Objection No. 3

Licence Ref. No: W0184-02

Objection to the Proposed Determination

Figure 1: Annual Average benzene concentrations (from the RTO and Carbon Filters - excluding background) as a result of the proposed benzene mass emission limit.

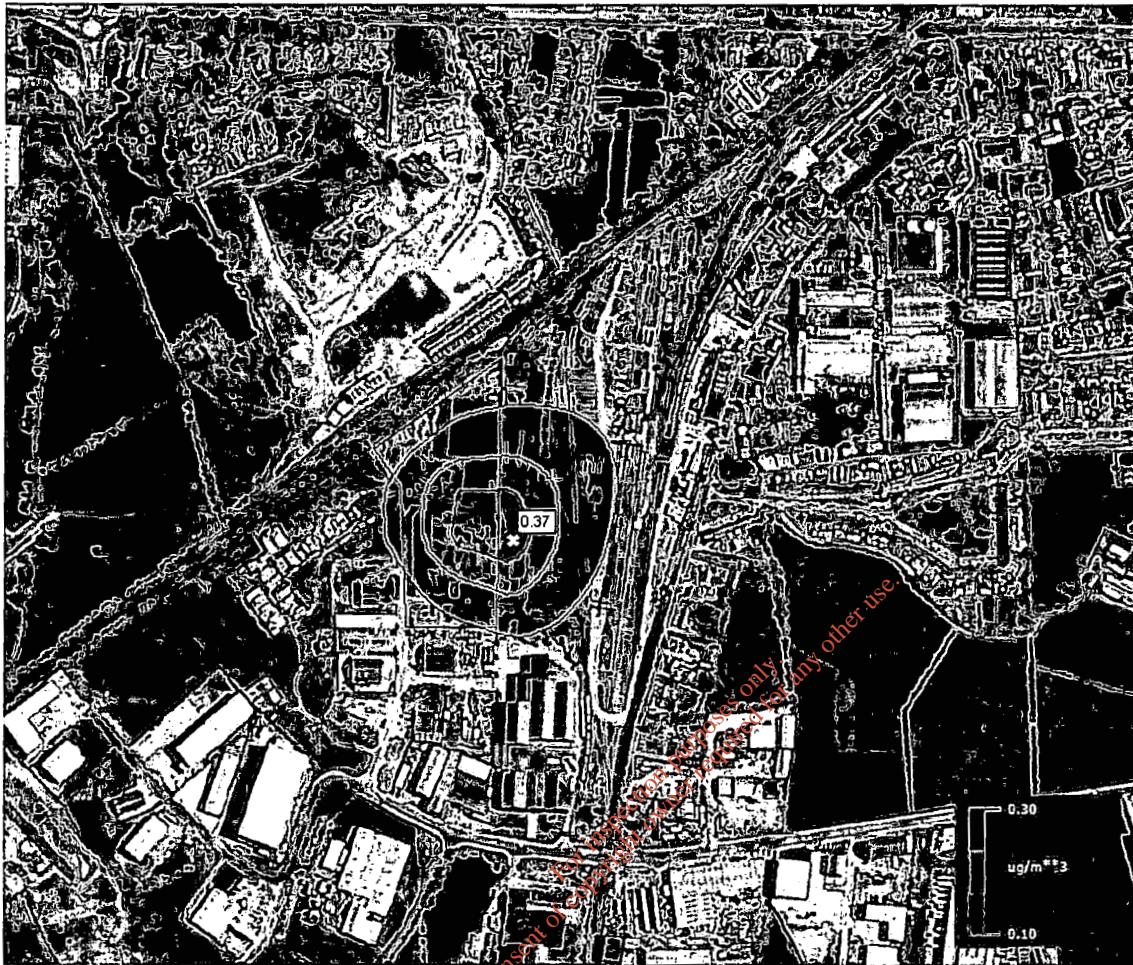
Given the concerns of the Inspector in relation to benzene and in the interests of ensuring full transparency of the emission levels of key pollutants such as benzene, Enva propose that routine compliance monitoring for benzene is undertaken and the appropriate emission limit value is applied for this parameter. The TA Luft 2002 cites that benzene is a Class III carcinogenic substance and the following guidelines apply:

Given there are seven potential sources of benzene at the Enva facility the aggregated emission rate for benzene is therefore 0.0175 kg/hr ($7 \times 2.5\text{ g/hr}$). This limit should be applied for benzene which will be specifically tested in the monitoring regime. Modelling of all seven sources at this mass emission rate is shown graphically in Figure 1 which demonstrates that the maximum ground level concentration if all stacks operated at this ELV would be $0.37\mu\text{g}/\text{m}^3$ compared to the limit value of $5\mu\text{g}/\text{m}^3$ and hence no significant impact from benzene on the surrounding environment.

In addition to the change in the aggregated limit in Schedule B.1, Enva request that the emission limit values for the carbon filters listed in Schedule B.1 are also modified as follows:

Source	Total Organic Carbon (as C) Mass Emission Limit (kg/hr)	Benzene Mass Emission Limit (g/hr)
A3-52	0.5	2.5
A3-53	0.5	2.5
A3-54	0.5	2.5

A3-55	0.5	2.5
A3-56	0.5	2.5
A3-57	0.5	2.5
